AGENDA
NOVEMBER 3, 2026
LAVON CITY COUNCIL
CITY HALL, 120 SCHOOL ROAD, LAVON, TEXAS
REGULAR MEETING
6:30 PM

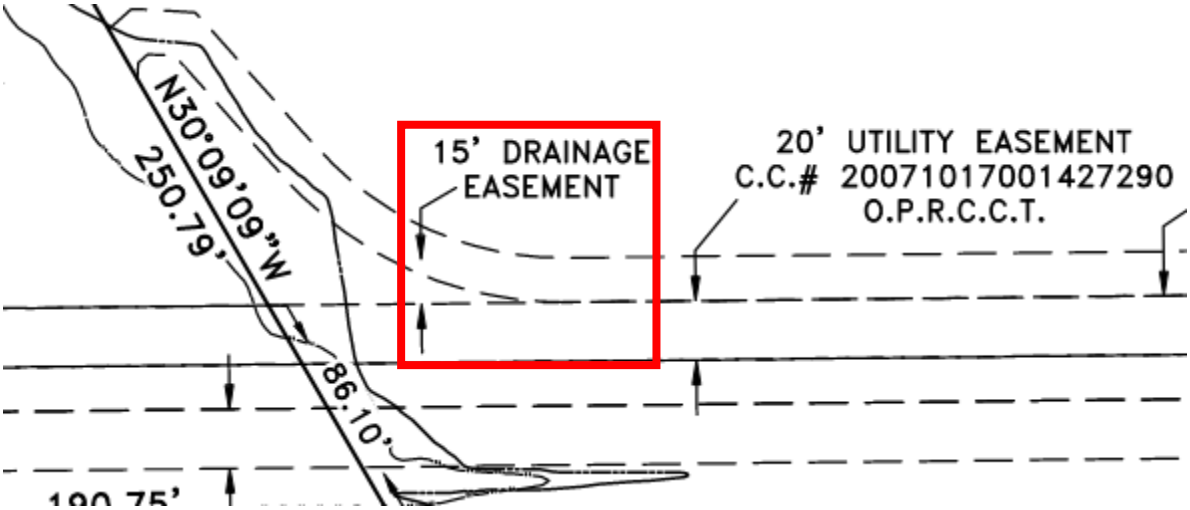
7. Revise General Note 4 to include the following:

“All common areas shall be owned and maintained by a Property Owners’ Association (POA), common to the development, and shall be open for public recreation and pedestrian

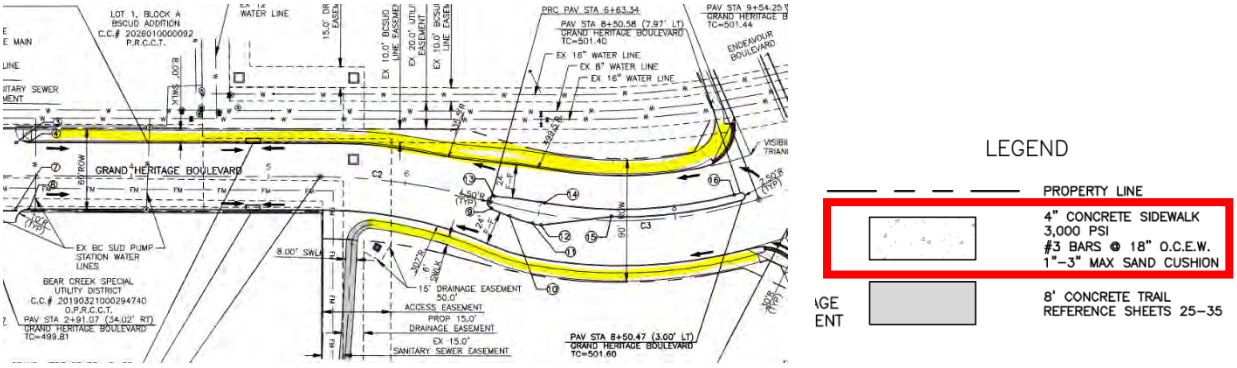
Revise the Final Plat and Paving Plan to detail the 6-foot sidewalks along the following roadways per the PD:

Required public sidewalks shall be constructed as follows:
a. 6 feet along State Highways (where re-construction is necessary to accommodate turn lane improvements)
b. 6 feet wide along Endeavor Boulevard
c. 6 feet wide on Grand Heritage Boulevard, north of Endeavor Boulevard
d. 6 feet wide on the west side of Grand Heritage Boulevard, south of Endeavor Boulevard
e. 6 feet wide on the east side of Grand Heritage Boulevard, south of Endeavor Boulevard
f. 6 feet wide along Geren Drive

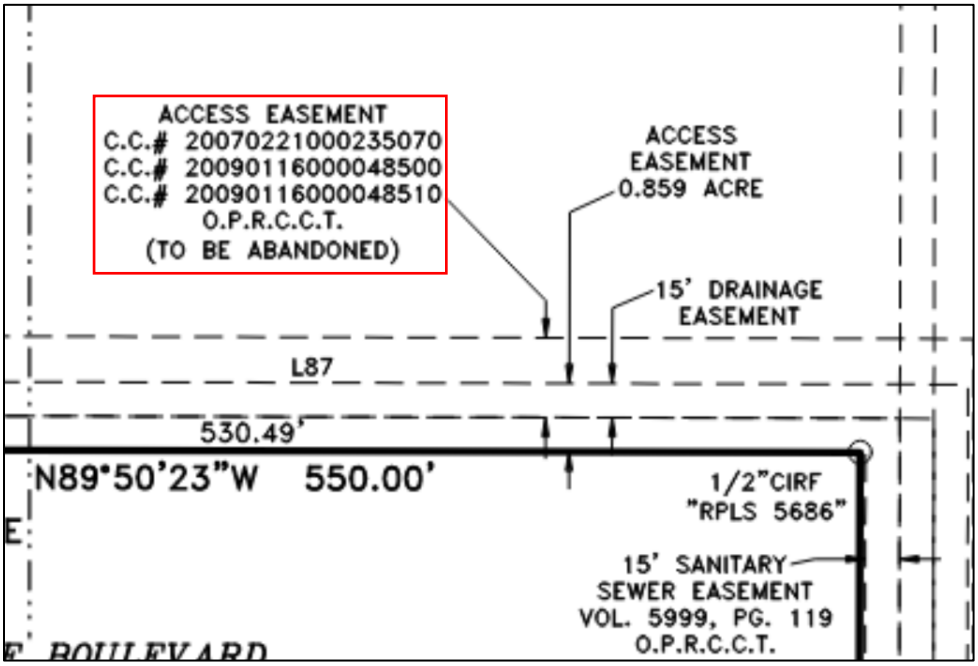
5. Revise the Final Plat to add all existing and proposed easements associated with proposed Lot 6, Block A.

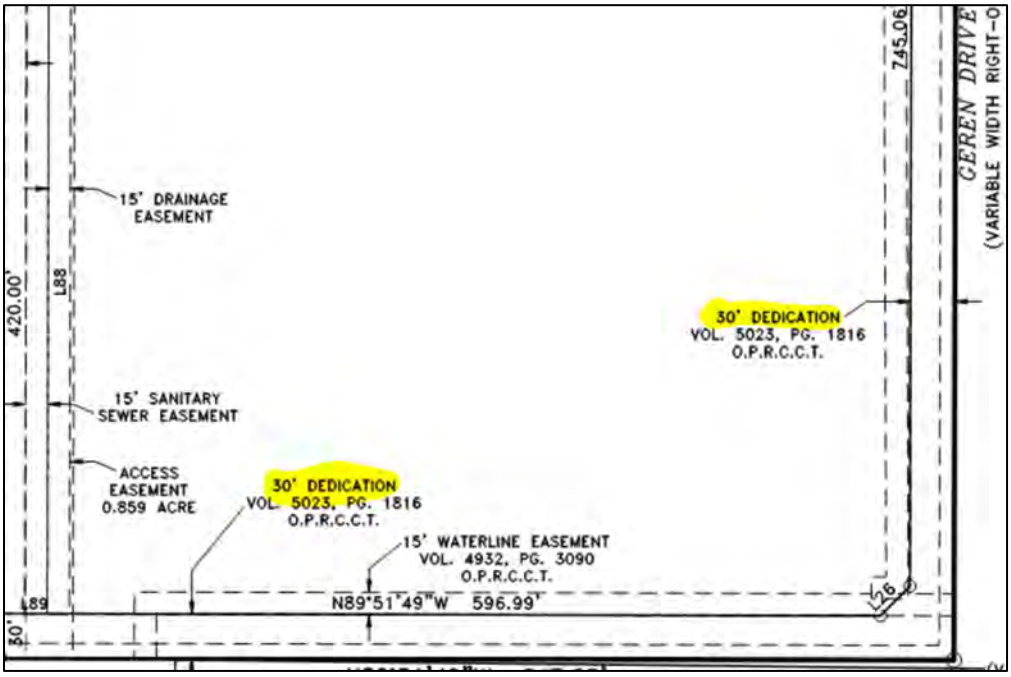
6. Should the three existing access easements be proposed to be abandoned by this plat, revise the Final Plat to update the label to state, “abandoned by this plat.” Please also coordinate with BCSUD to ensure they are informed of this change.

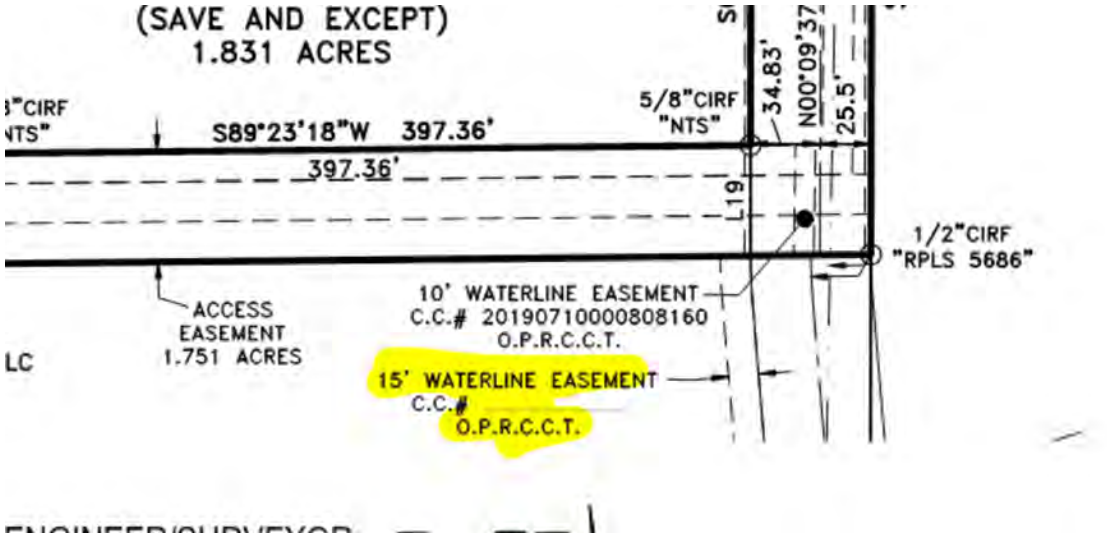
7. Revise the Plat to remove all previously dedicated right-of-way from the subject property:

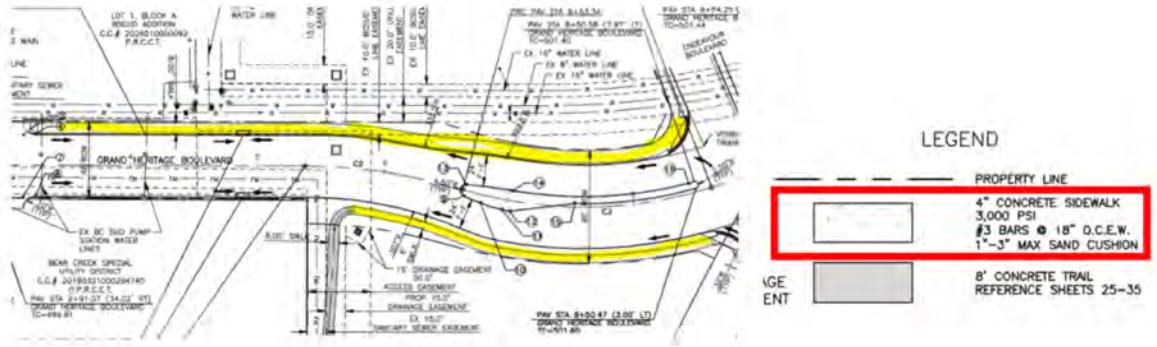
Revise the Final Plat and Paving Plan to detail the 6-foot sidewalks along the following roadways per the PD:

> Required public sidewalks shall be constructed as follows:
> a. 6 feet along State Highways (where re-construction is necessary to accommodate turn lane improvements)
> b. 6 feet wide along Endeavor Boulevard
> c. 6 feet wide on Grand Heritage Boulevard, north of Endeavor Boulevard
> d. 6 feet wide on the west side of Grand Heritage Boulevard, south of Endeavor Boulevard
> e. 6 feet wide on the east side of Grand Heritage Boulevard, south of Endeavor Boulevard
> f. 6 feet wide along Geren Drive

Response: The legend detail specifies the sidewalk as four inches thick, not four feet wide. All sidewalks are proposed as six feet wide, which matches the PD.

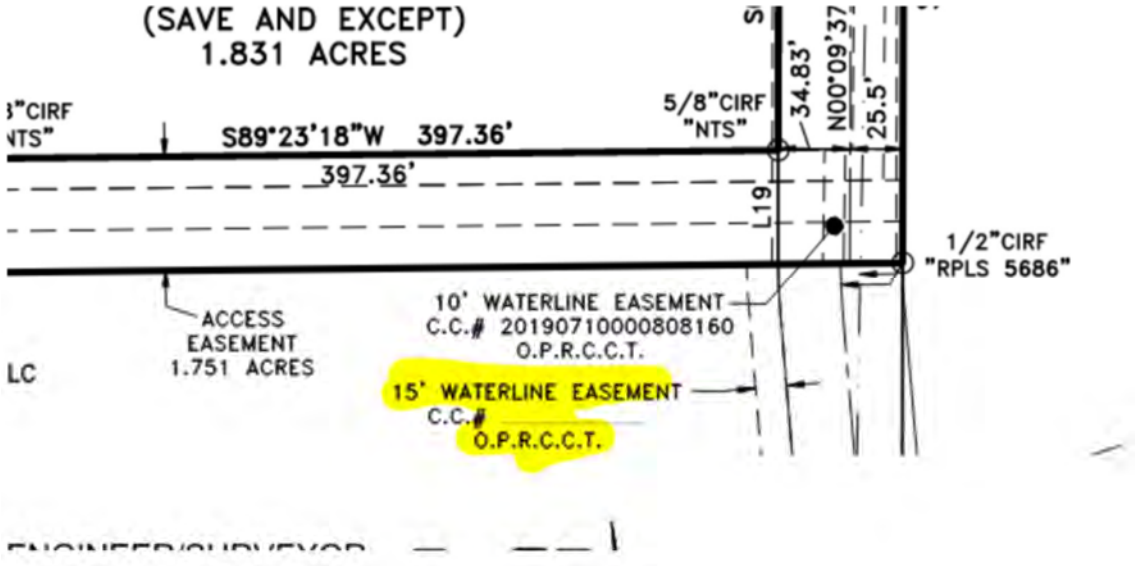
7. Revise the Plat to remove all previously dedicated right-of-way from the subject property:

Response: The 30' dedication by separate instrument recorded in V 5023, P 1861 will need to remain, it is a recorded easement granted to the City.

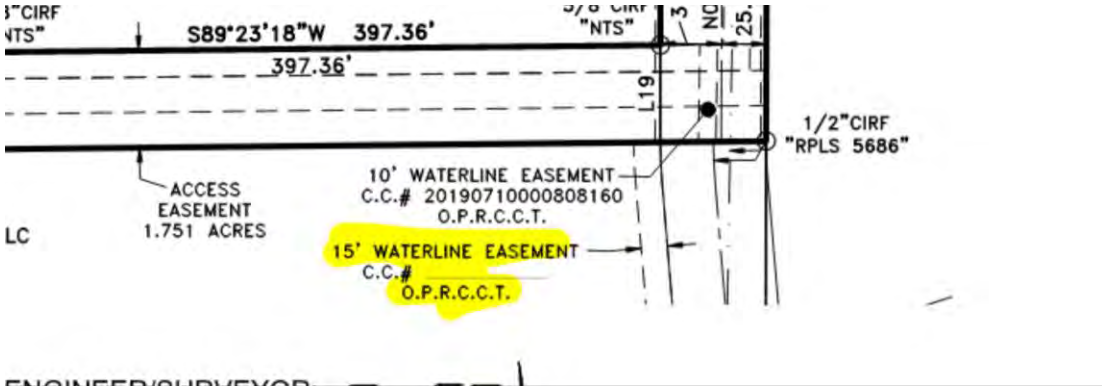
4. **Revise the Plat to remove all previously dedicated right-of-way from the subject property (as highlighted below). The filing information can remain, but the areas should be removed from the subject property, as they are public right-of-way.**
